Product Change Notice

Implementation of gold studs at LED conductive epoxy dispensing area.

- AEDR-9820-100
- AEDR-9820-102
- AEDR-9830-100
- AEDR-9830-102
- AEDR-9920-100
- AEDR-9920-102

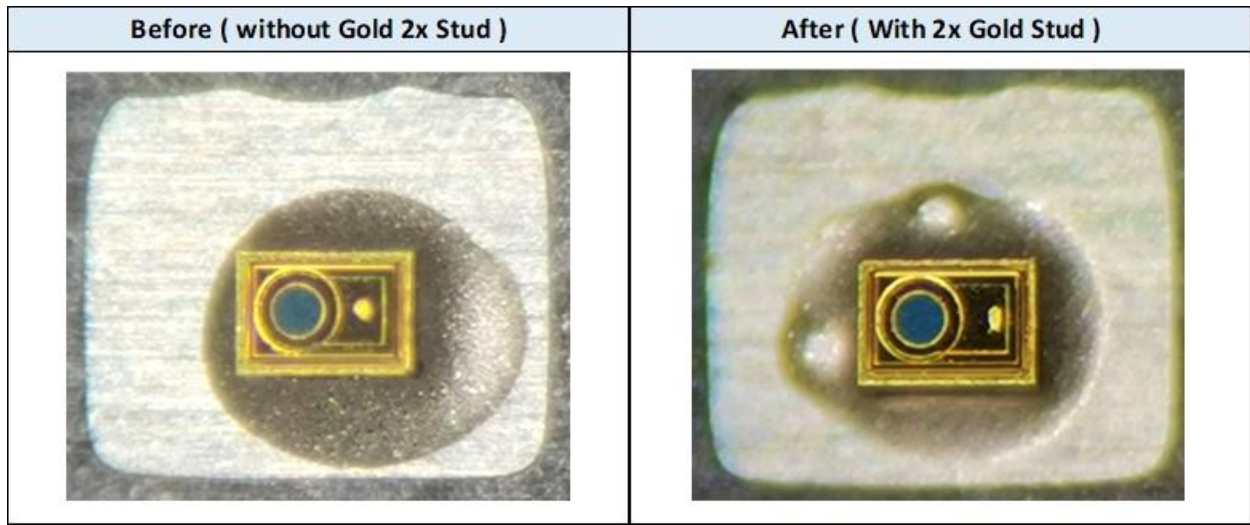
- 1) The additional gold studs enhance the LED epoxy conductivity to the package metal pad.
- 2) This implementation is leveraging from other similar reflective encoder product family AEDR-98xxA and AEDR-9930, qualified for volume production
